**PRE-1972**  
**SERVICE BULLETINS**  
for  
**Rolls-Royce Silver Shadow**  
and  
**Bentley T Series**

15D-1190000-1859

Fig.2 Stiffened bottom cover -  
Torus unit

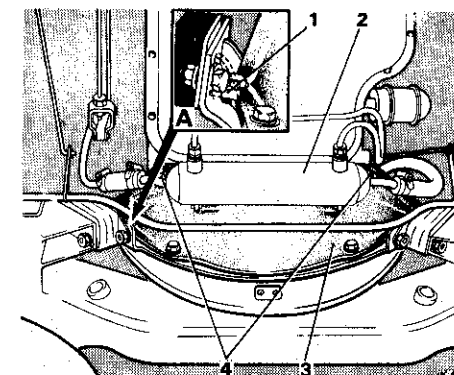
4. Remove the two lower engine foot gusset plates from the assembly plate (see Fig. 2). These are best removed using a cold chisel, the faces being filed flat afterwards.
5. Enlarge the two holes in the transmission casing where shown in Figure 2 and tap the hole to  $\frac{3}{8}$  in. U.N.C.  
Recommended drill size 0.315 in. (8.00 mm.)  
Alternative size 0.3125 in. (7.94 mm.)
6. Check for any casting flash on the sloping bottom face of the torque converter transmission casing.

Fig.1 Rear disc brake calipers

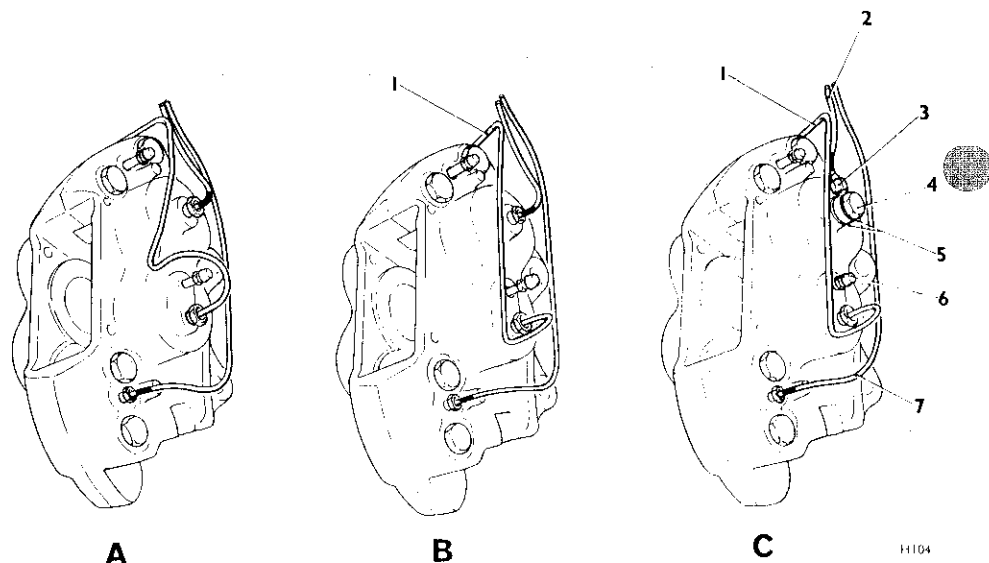
- | A. Original brake pipework        | B. Stage 1 modification | C. Stage 2 modification        |

Fig.2 Method of fitting fulcrum pin retaining clip

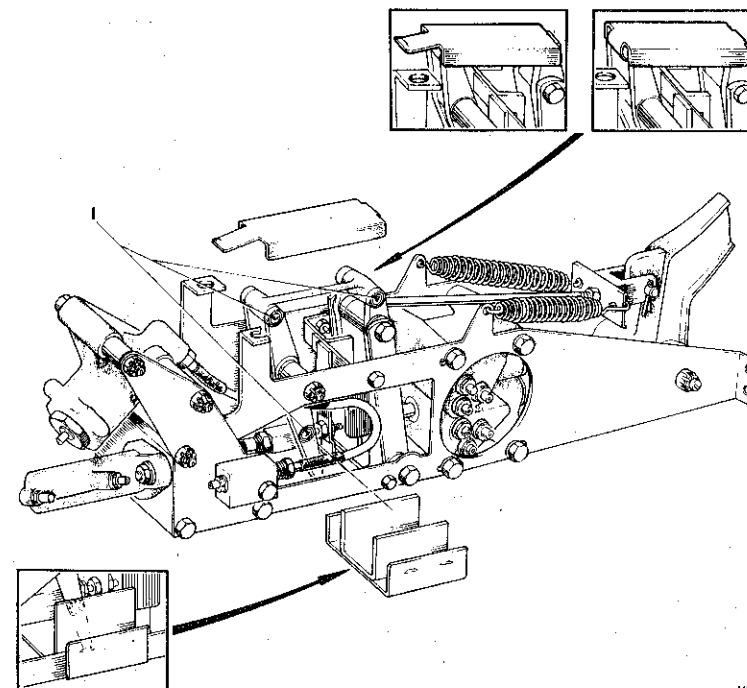
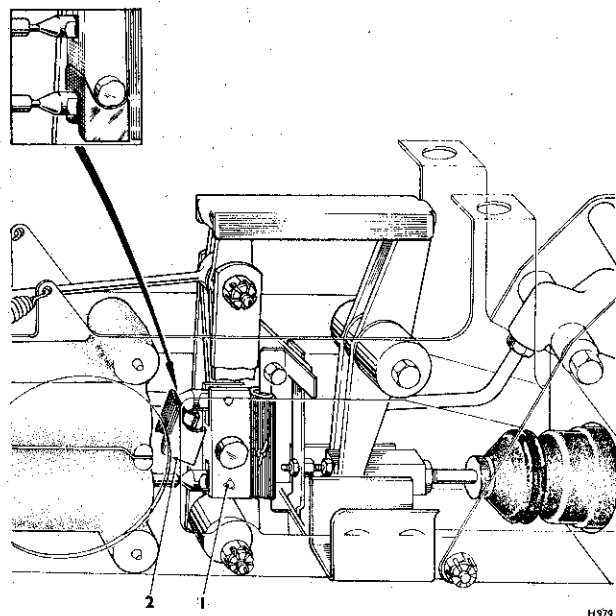
The modifications which have been devised are in the form of three clips which can be fitted in position on the car in a matter of minutes and once in position they will retain the brake linkage pins even if they become slack. These clips will only be fitted retrospectively on cars in service and will not be fitted on cars produced after car number 3384.

1. Place the car on a ramp or over a pit.
2. Remove the brake actuation mechanism undertray.
3. Spring the three retaining clips into position as shown in Figures 1 and 2. When the upper clip is in position the tang at its forward end should be bent under the link as shown in the inset in Figure 1.

Fig.1 Sectional View - Hydraulic accumulators

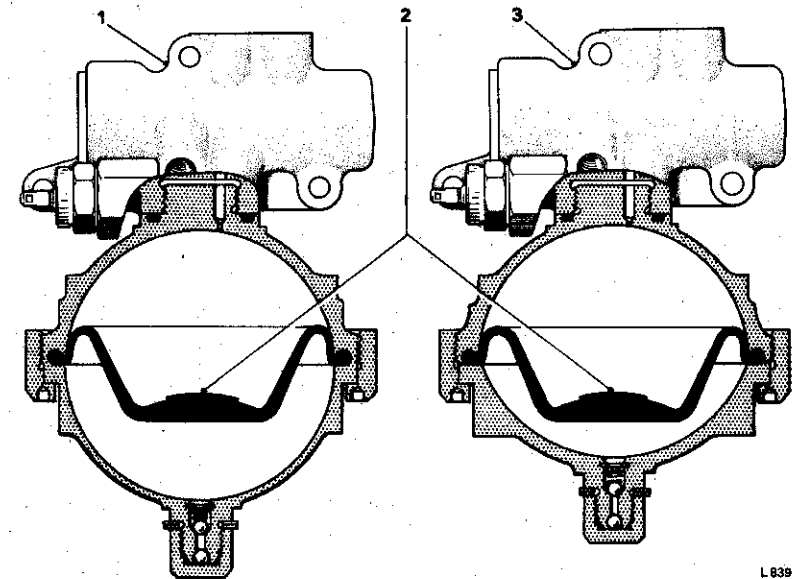
The new diaphragm when in its free state adopts the form outlined in the cross section shown in Figure 1.

It is most IMPORTANT when overhauling an accumulator sphere that the new diaphragm is fitted the correct way up. This is achieved by fitting the diaphragm as illustrated in figure 1. The moulded lip of the diaphragm will then sit neatly onto the machined seat, situated in the upper half of the sphere.

Fig. 1 Piston and bobbin assemblies

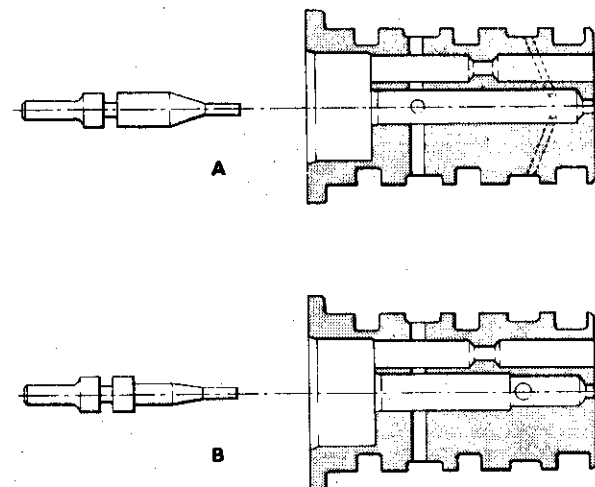
The two piston and bobbin assemblies are illustrated overleaf in Figure 1.

FIG.2 Front Suspension Damper Arrangement - Current Type

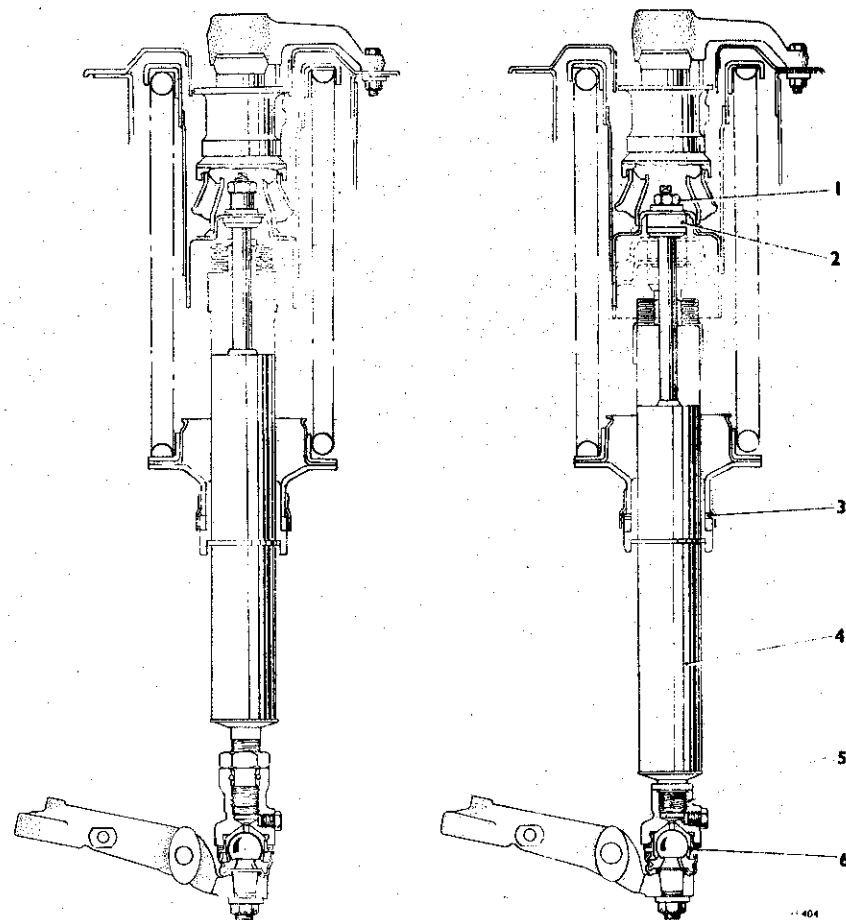
The front shock damper arrangement shown in Figure 1 is common to production cars built prior to the following car numbers - SBH 1433 and CRX 1583.

The front shock damper arrangement shown in Figure 2 is common to cars produced after the foregoing car numbers with the exception of the following cars which have the arrangement shown in Figure 1.

The arrangement shown in Figure 2 which supersedes the Figure 1 dispenses with the fine screwed adjustment. However, fine adjustment can still be achieved by utilising a new packing piece which is 0.064 in. (1.59 mm.) thick. It is permissible to position a maximum of six of these packings, if required, with the existing thicker packings beneath each front spring seat.

To determine which arrangement is fitted to a particular car, a visual check at the lower ball joint housing will suffice. If there is a lock nut present above the ball joint housing next to the shock damper casing, then the arrangement is the earlier type as shown in Figure 1.

The absence of a lock nut denotes the current arrangement shown in Figure 2 which means that no screwed adjustment should be attempted when setting the car front height.

Fig. 1 Displaced and new shock dampers

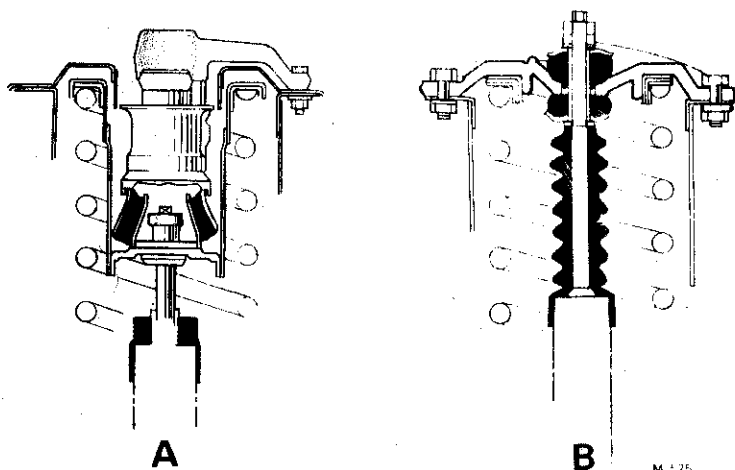
- A. Displaced shock damper arrangement  
B. New shock damper arrangement

Fig. 1 Modified circuit for coolant level indicator

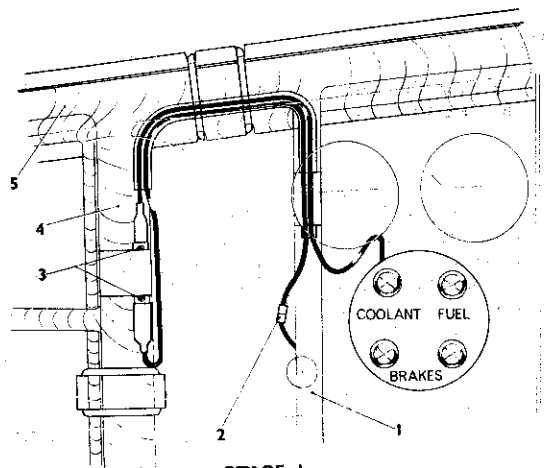
Both stages shown in Figure 1 are applicable to left-hand drive cars; right-hand drive cars are symmetrically opposite.

Before any work is undertaken, it should be ascertained whether this modification has been carried out previously. This can be checked by lowering the fuseboard and tracing the fuseboard branch loom upwards; the diode, if fitted, will be taped to the fuseboard branch loom as shown in Figure 1.

Fig.1 Starter motor  
with slot

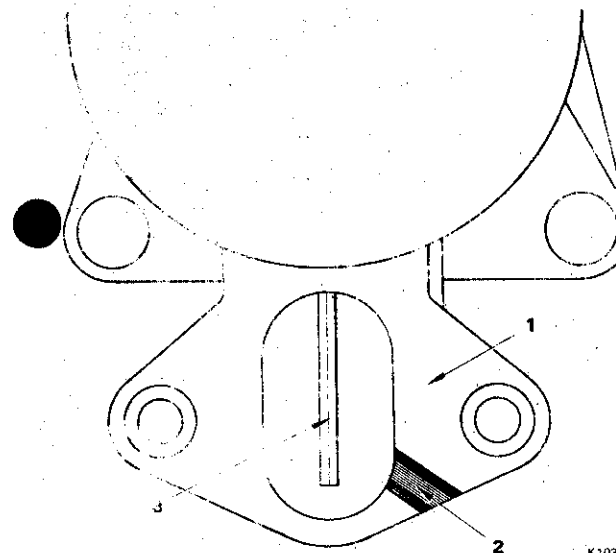
4. Push a clean piece of cloth into the solenoid mounting boss such that the engaging lever will be protected from filings.
  5. Using a 0.250 in. (6,40 mm.) round file, cut a slot 0.250 in. (6,40 mm.) in depth across the solenoid mounting face, as shown in Figure 1.

Fig.1 Relay box viewed on underside

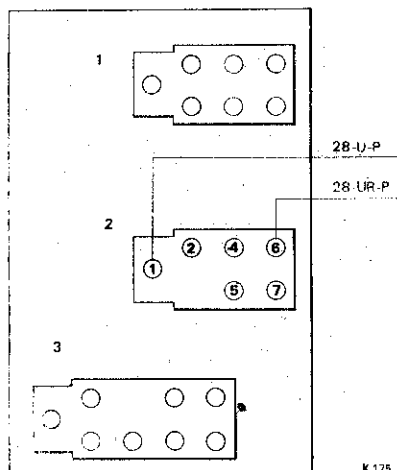
9. Remove the blue plastic covered cable and the blue/red plastic covered cable from cavities 1 and 6 respectively in the relay board socket 'U' as shown in Figure 1.

10. Prepare a new cable 3.0 in. (7.62 cm.) long using 14/.010 blue/red plastic covered cable. Link the end of the cable removed from cavity 6 of socket 'U' to one end of the new cable, using a terminal, Rolls-Royce part number UD 11874. Fit this terminal to cavity 6 of socket 'U' as shown in Figure 2.

11. Using a terminal, Rolls-Royce part number UD 11874, connect the other end of the new cable to the cable removed from cavity 1 of socket 'U'. Fit this terminal to cavity 1 of socket 'U' as shown in Figure 2.

**Fig. 1 Wiper motor to mounting bracket securing arrangement**

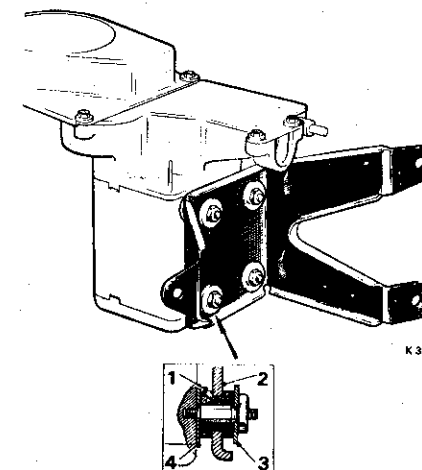
The purpose of this Service Bulletin is to advise Service Personnel that in the event of a customer complaint of excessive wiper mechanism noise on an early car a considerable reduction in motor noise level can be made by reducing the number of washers fitted between the motor casing and the grommet to one, as shown in Figure 1. This will increase the flexibility of the mountings and reduce the noise level.

Fig. 1 - Position of spacer

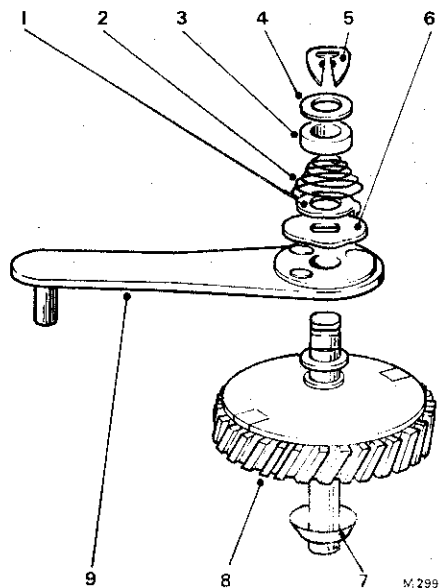
However, it is possible to overcome this extra friction by increasing the force applied by the spring to the wave washer of the anti-streak mechanism. This is achieved by fitting a packing piece between the top of the spring and the existing washer as shown in Figure 1.

Fig.1 Lockplate in fitted position

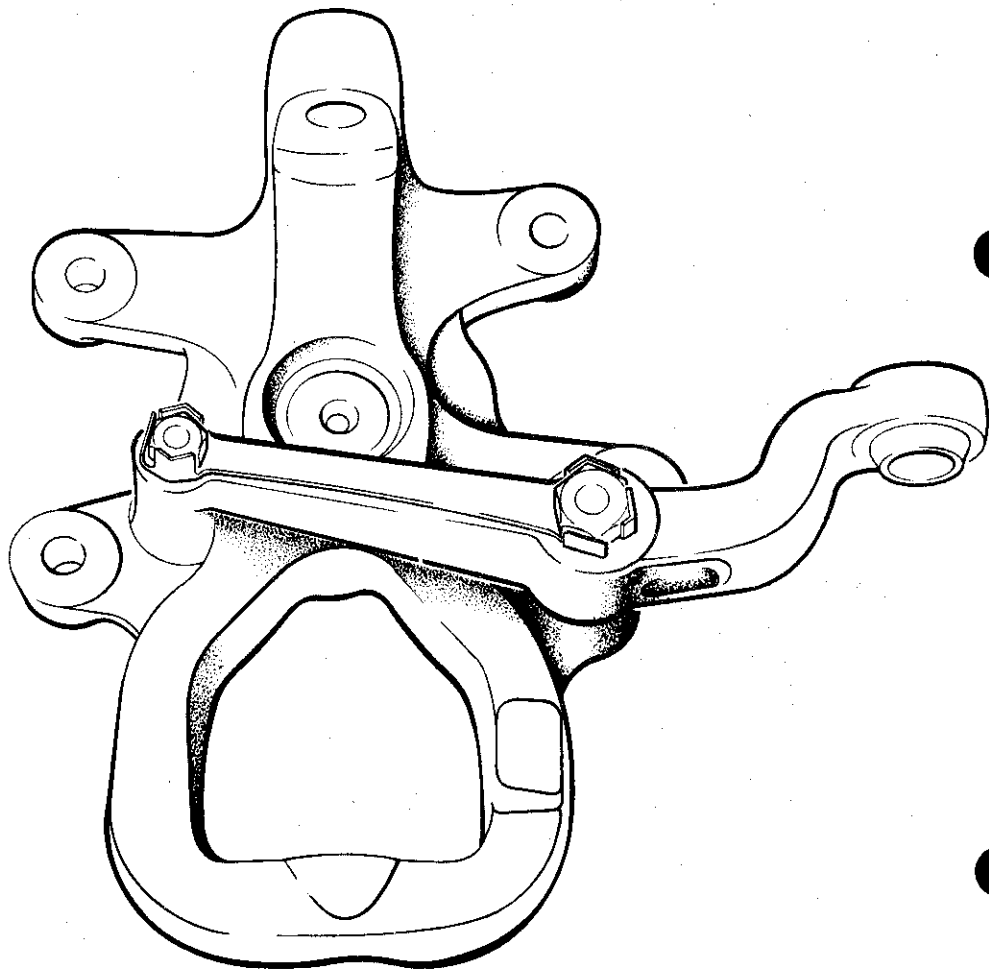
The modification consists of a stainless steel lock plate fitted under the heads of the two setscrews as shown in Fig. 1.

Fig.2 Lock tabs - Pre-bent  
(Shaded area to remain flat)

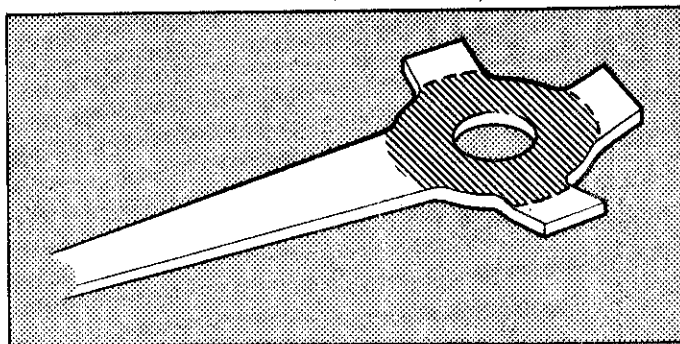
To facilitate the tabbing operation the end of the tabs may be bent upwards slightly before fitting as shown in figure 2. As shown in the diagram, only the ends of the tabs should be bent upwards and it is important to note that the shaded area should remain flat.
